ATR on Quality Control Check Report. (Apartments)

Quality Control Check Report. Stage: After Plumbing & Electrical (Apartments)

GULMOHAR RESIDENCY

Details of Additions & Alterations

Description	Owners & Developers	Date	Promoted by
ELECTRICAL PLAN - 1360 sq ft FLATS-A2 TYPE	Modi Realty Mallapur LLP	21.09.2020	Modi Properties Pvt Ltd
	Project Name & Phase	Prepared By :	Jayagraha
	Guilmoher Residency	Approved By :	Soham Modi
		Scale :	N T S

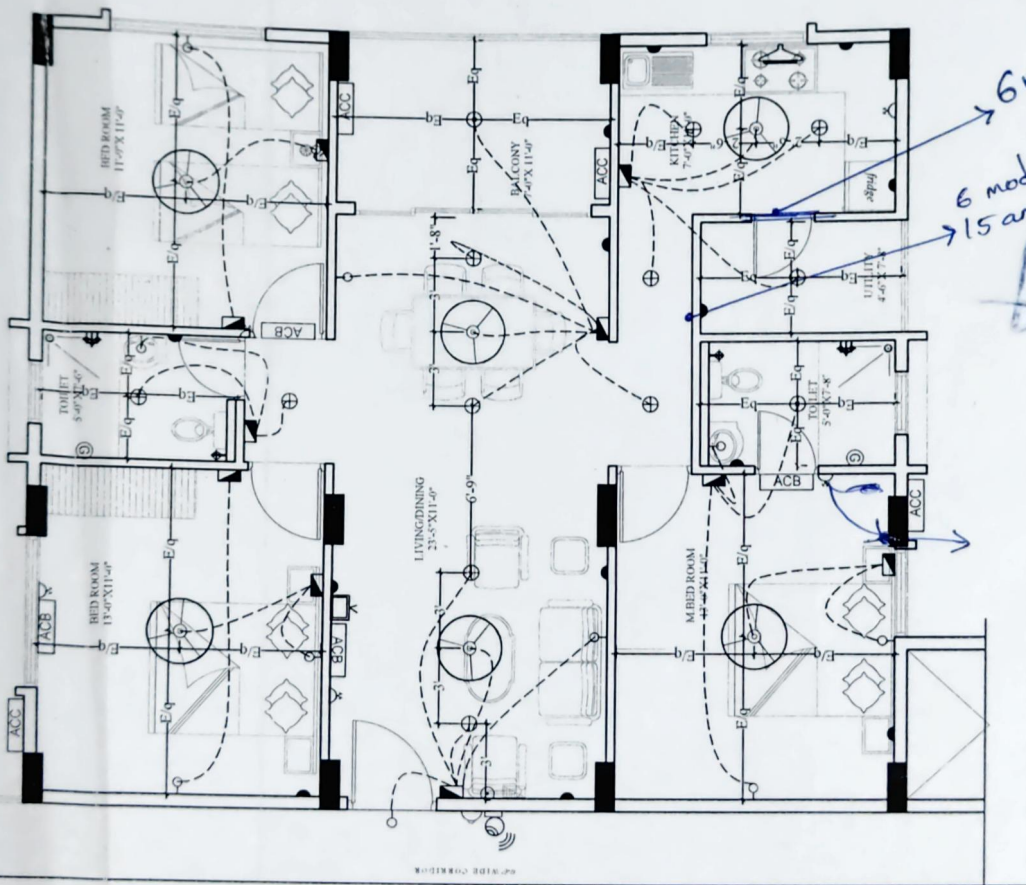
Changes in electrical points: (mark on plan)

601 - Kitchen Plot form is same as 302.
